City of Ryde Submission Stocklands 1-5 Khartoum Road Macquarie Park SSD Data Centre

SSD-63235720

**Submission Date: 28 March 2025
COR2025/146/1**

Figure 1: Markup of Macquarie Park Corridor Map (Base Source: RLEP 2014 PMC_004)

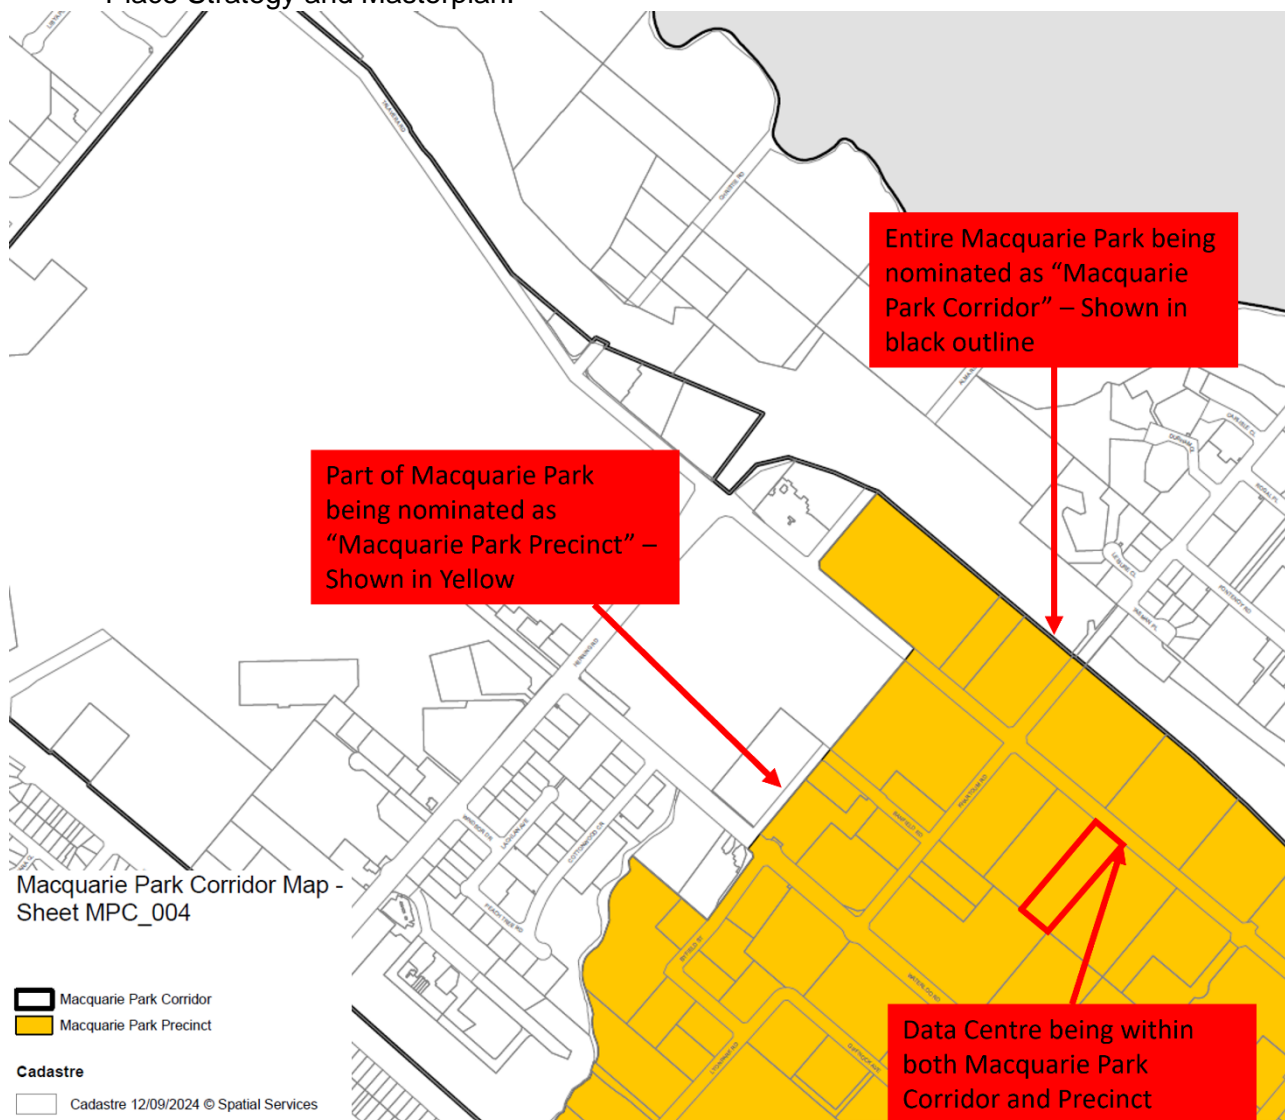
The EIS states that the site is not within the Macquarie Park Corridor map, however that is not correct. Extract from EIS:

The site is located on land identified within the Macquarie Park Precinct. Accordingly, a consistency assessment against the Macquarie Park Innovation Precinct Place Strategy is not required.

Under the gazetted map (Macquarie Park Corridor Map -Sheet MPC_004), the site is nominated as being within both the Macquarie Park Corridor (Corridor) and Macquarie Park Precinct (Precinct) as shown in Figure 1. The Corridor Map refers to the entirety of Macquarie Park for which the Place Strategy and Master Plan was prepared for, whilst the Precinct Map refers to land that benefits from

the Ryde Local Environmental Plan 2014 (RLEP 2014) incentive bonuses under the now Part 7 (Previous clause 6.9) of the RLEP 2014.

- The Applicant is to provide a detailed statement of consistency with the application against Place Strategy and Masterplan.

Figure 3: Extract showing excessive flooding figure C2 (Source: Northrop)

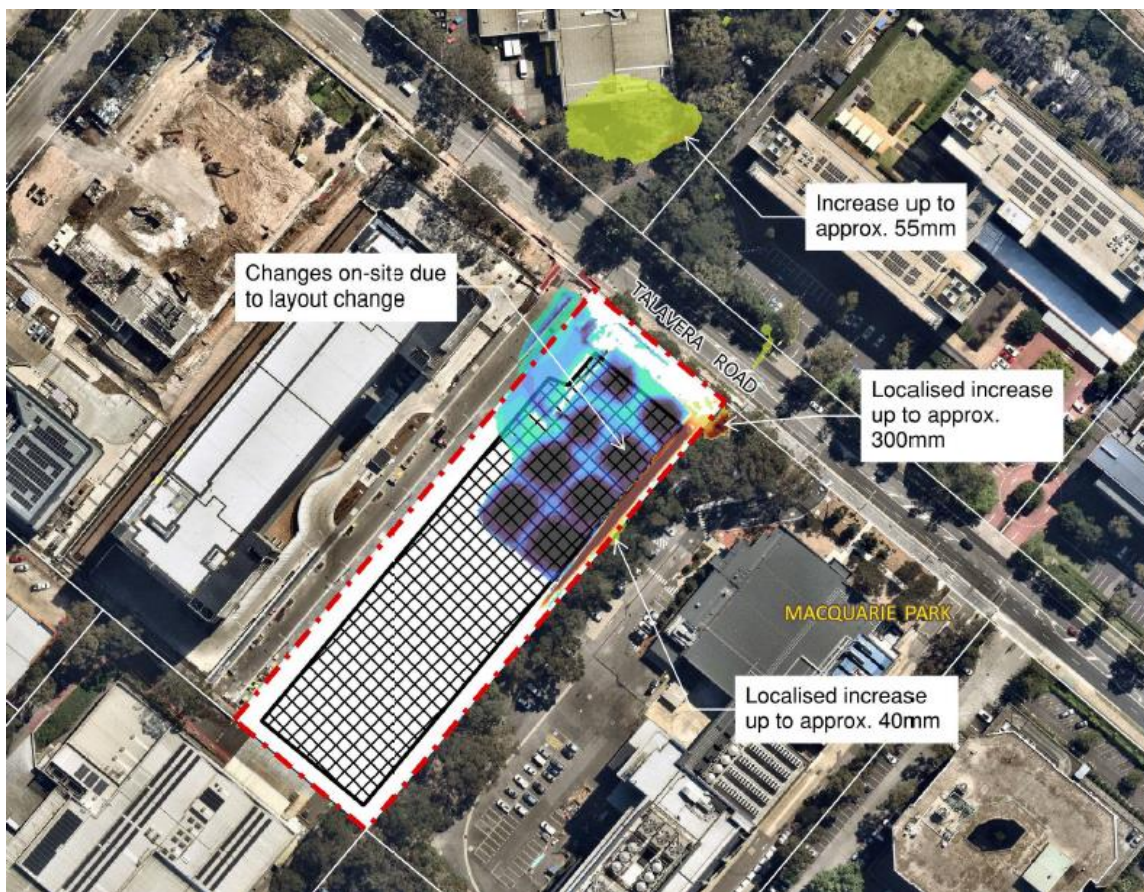
It appears that the post development scenario increases the flood depth in the neighbouring properties excessively as shown below:

Due to flooding in Talavera Road and the sites' location, and the developments footprint exacerbating flooding conditions, Council suggests to effectively resolve these issues that the applicant address and provide the following information:

- A detailed Drainage/Stormwater Management Plan to be provided that considers:
 - The proposed method of site drainage to be shown.
 - The proposed connection details, including the pit and pipe, must be clearly indicated on the plan.

Figure 5: Stormwater Pipe to be upgraded shown In orange (Source: City of Ryde Council)

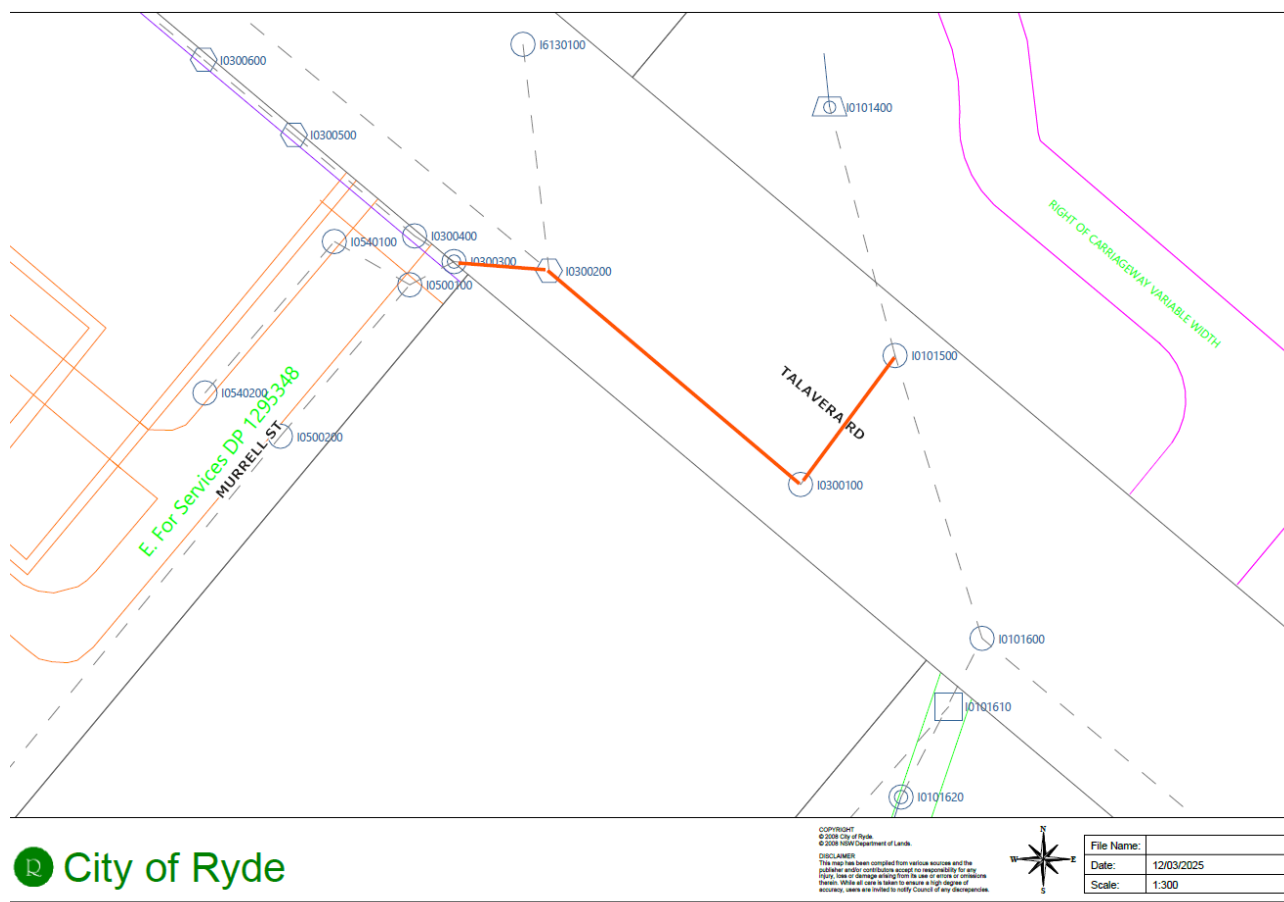
- Notably, the adjacent development at 17-23 Talavera Road has already upgraded the upstream drainage pipe. Without similar improvements, the proposed development may create a bottleneck in the area and adverse flooding conditions.

- Note above comments regarding flooding models to be provided
- To minimise the flooding impact within Talavera Road, the applicant will be required to upgrade the adjacent drainage network as shown in Figure 5 :

- Council will provide a detailed condition of consent requiring the above be completed.
- Drainage network capacity analysis must be demonstrated to ensure the proposed development can be effectively drained and managed via the downstream drainage network.
